MORSpeed Head Internal Springs

Replace Spring Set # 920-P with # 921-P

Spring Set # 920-P (DISCONTINUED)

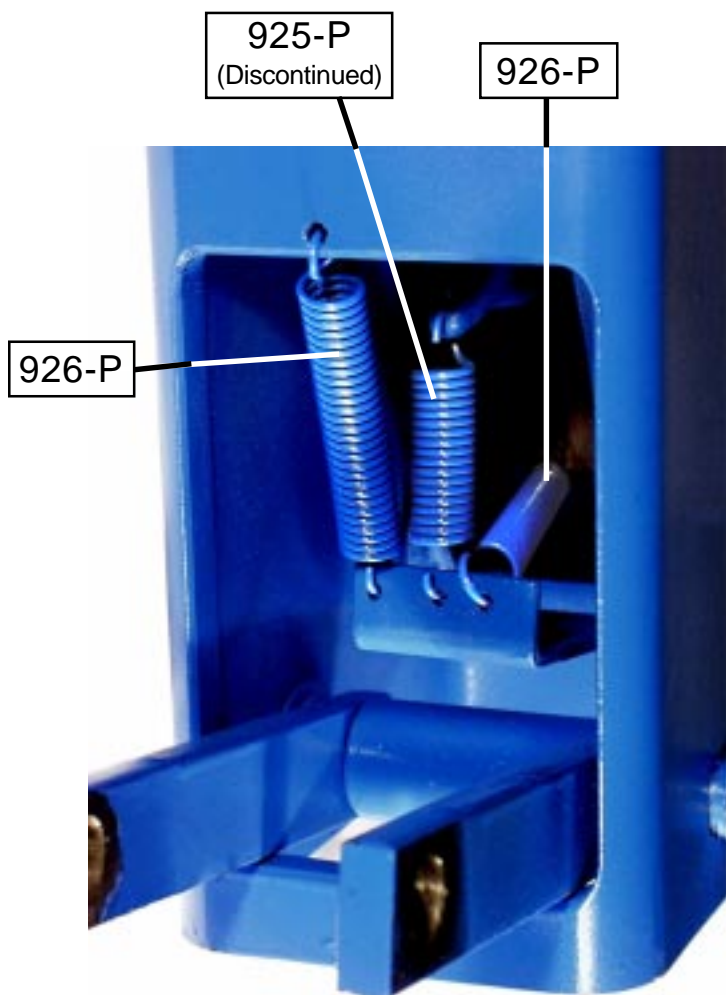
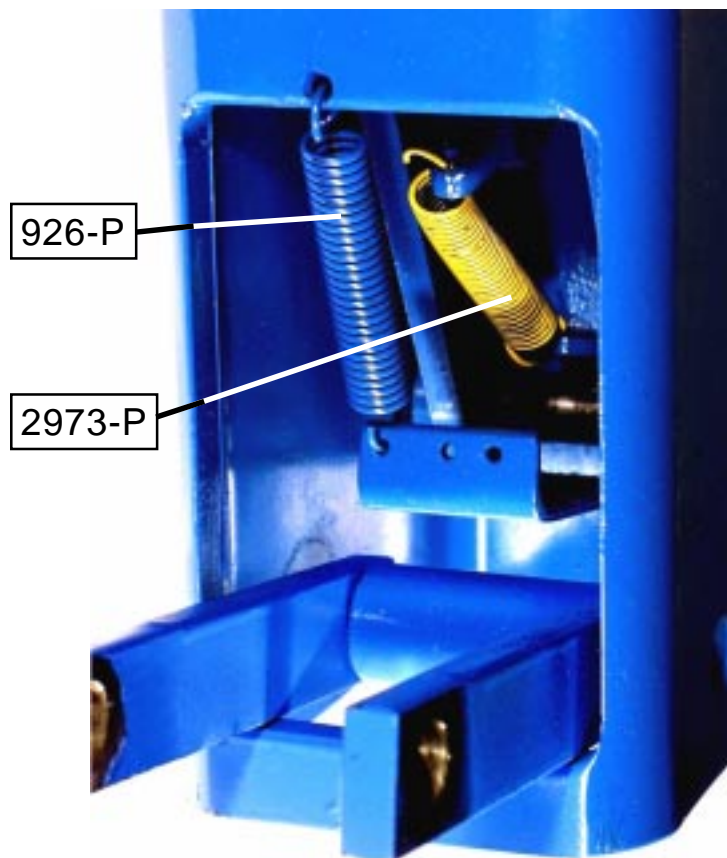
• Part Number 920-P SPRING SET included:

Qty.	Part #	Description
(2)	926-P	MEDIUM Spring
(1)	925-P	SMALL Spring
(1)	927-P	LARGE Spring - not shown

Qty.	Part #	Description
(1)	926-P	MEDIUM Spring
(1)	2973-P	LOW TENSION Spring
(1)	927-P	LARGE Spring - not shown

• Part Number 921-P SPRING SET includes:
